In re Application of:)	
	:	Examiner: W. Royer
NORIIHIKO KUBO)	
	:	Group Art Unit: 2852
Application No.: 10/068,842)	
	:	
Filed: February 11, 2002)	
	:	
For: CLEANING APPARATUS)	December 1, 2003
INCLUDING A TONER BREAKING	:	
MEMBER AND IMAGE FORMING)	
APPARATUS USING SAME	:

REQUEST TO MAKE DRAWING CHANGES

FIG.1

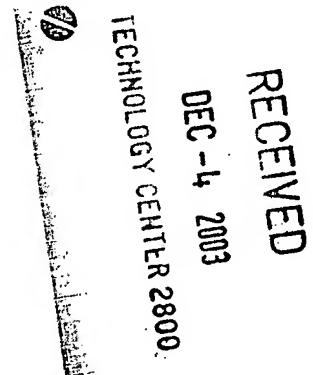
Enclosed are copies of proposed drawings changes shown in red ink to Figure 1.

These changes consists of adding arrows denoting a rotation direction of the photosensitive drum 3a and the transfer belt 130, reinserting reference numeral 7 to depict a pair of registration rollers, and redirecting the lead line of reference numeral 12 to depict a conveying guide. In addition, numeral 1s has been replaced with 13.
